STAFF REPORT
Docket No. SP-53-21
Summary No.
Site Plan Review
The Core

The Core
2901 Belle Chasse Hwy.

Apartment Complex
 with 9 Multi-Family
 Buildings

FIGURE 4

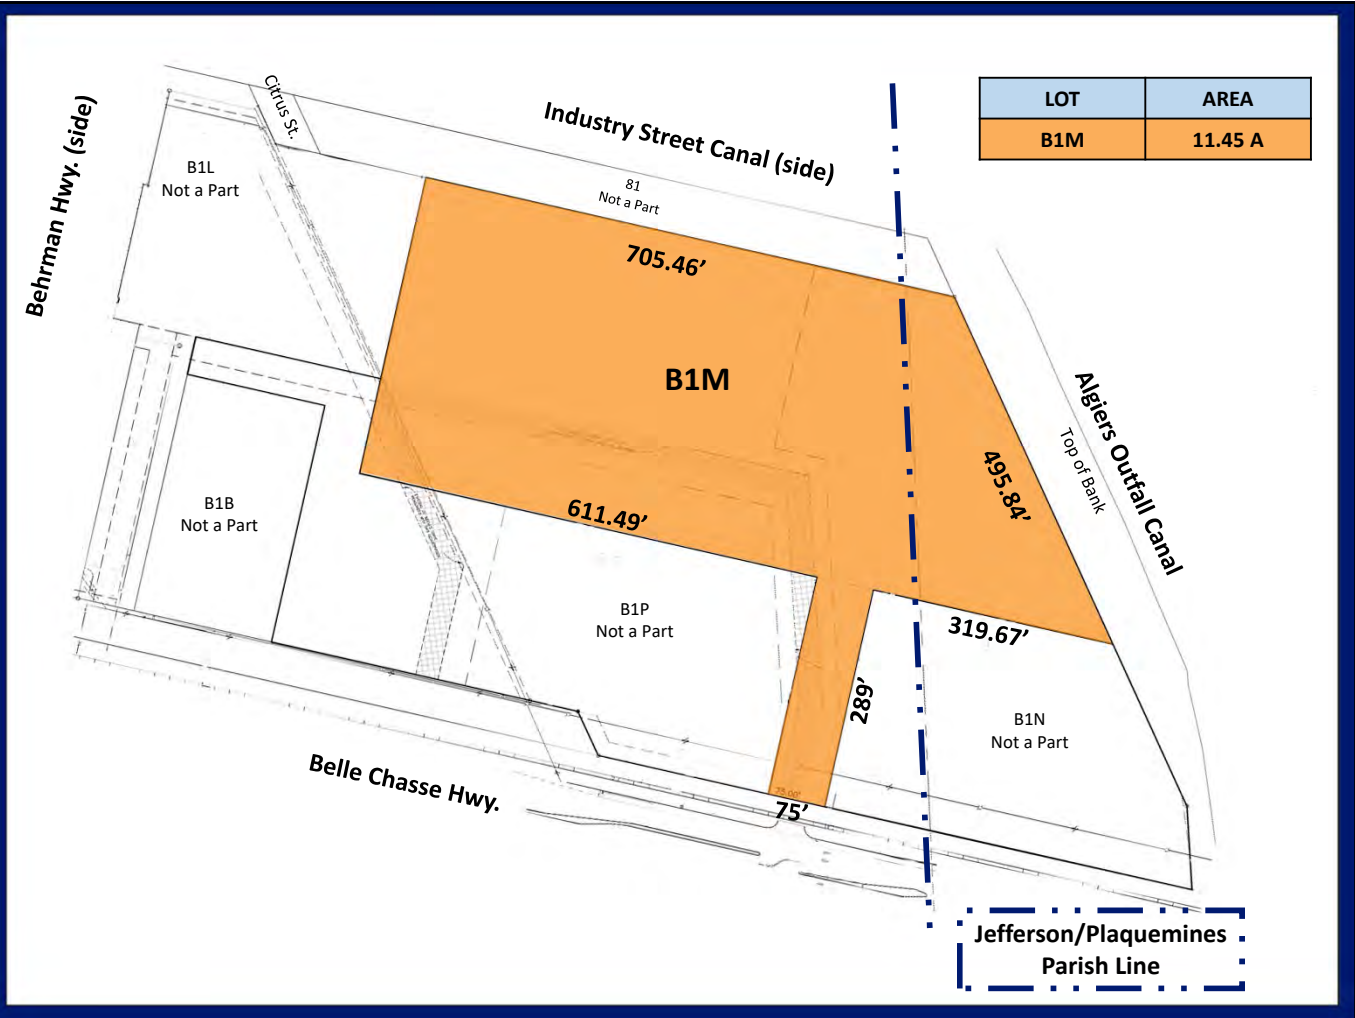
2. The petitioned property is an undeveloped 11 acre-lot (proposed Lot B1M) located on Belle Chasse Hwy near its intersection with Behrman Hwy/Lapalco Blvd. It is part of a concurrent subdivision request to subdivide 4 lots into 3 (WS-169-21). The lot is bisected by the Jefferson Parish/Plaquemines Parish line (Figure 4).

11. Sec. 40-444(c), MUCD Lot area, requires that the lot area per family shall be the same as in the R-3 Multiple-Family Residential District. The R-3 district requires apartments with 44 or more units to have a minimum lot area calculated at 700 sq. ft. per family. The site exceeds the minimum lot area per family as it is 11.4547 acres and the minimum for 192 units at 700 sq. ft. would be 3.0854 acres (Figure 4).

12. Sec. 40-444(d), MUCD Site Area Requirements, requires sites to be a minimum of 5 acres and have a minimum width of 200 ft. and a minimum depth of 500 ft. The site exceeds these requirements with an area of 11.4547 acres, average width of 1002 ft., and an average depth of 683 ft. (Figure 4).

FIGURE 5

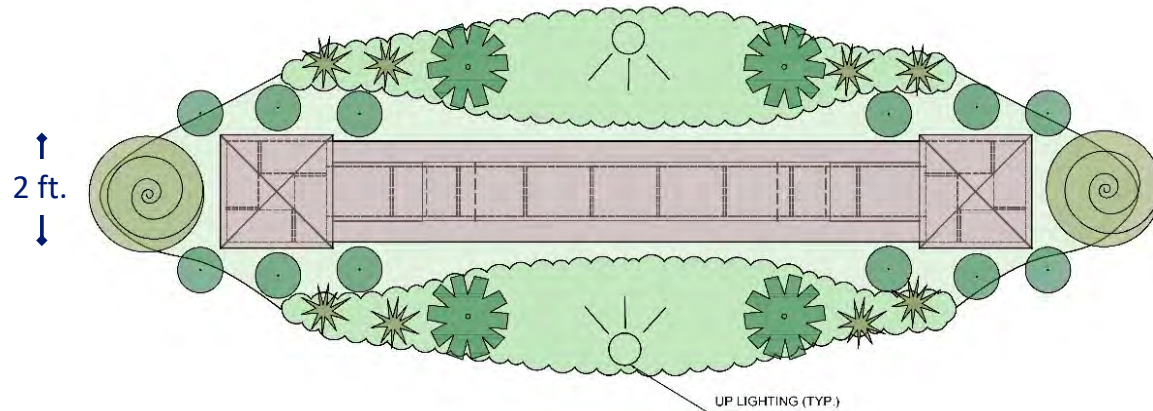
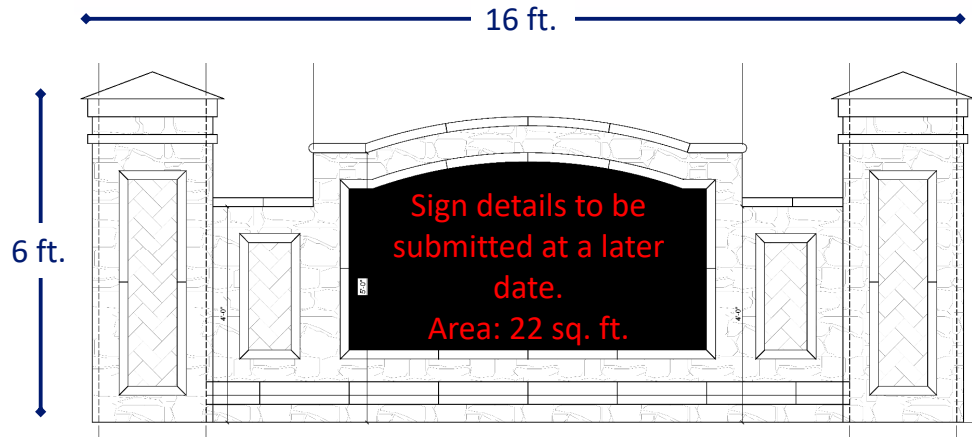
10. Sec. 40-444(b), MUCD Setbacks, requires a 20 ft. front yard setback and 10 ft. setbacks for side and rear yards. The configuration of the lot is similar to a flag lot and thus, the front yard is measured from the Belle Chasse Hwy. access along the portion of the lot that measures 75' frontage on Belle Chasse Hwy. by a depth of 289'. The only structure within this access is the monument sign. The monument sign is 22 ft. back from the lot line, all buildings are set back at least 90 ft. on either side, and all buildings are further than 10 ft. from the rear lot line (Figure 5). The site exceeds setback requirements.

15. Sec. 40-448(b)(3), MUCD Detached Signs, limits detached signs to only one. The site plan proposes one monument sign (the style encouraged in the Code) that meets area, height, and depth standards of the MUCD (Figure 5) (Table 4).
16. The landscape plan proposes 105 trees, 746 shrubs, and 742 perennials across the site. The parking lot is required to have a minimum of 26 islands or peninsulas, and 27 islands are proposed. The sign is required to be in a planting bed 2 ft. wide and at least 60 sq. ft. The proposed sign is in a planting bed 7 ft. wide with an area of 100 sq. ft. The site plan meets all additional landscaping requirements stipulated in Sec. 33-6.25.5 Greenspace Standards of the Unified Development Code (Figure 6).
17. The site plan meets the requirements stipulated in Sec. 40-447, MUCD General Design Standards. (Table 1)
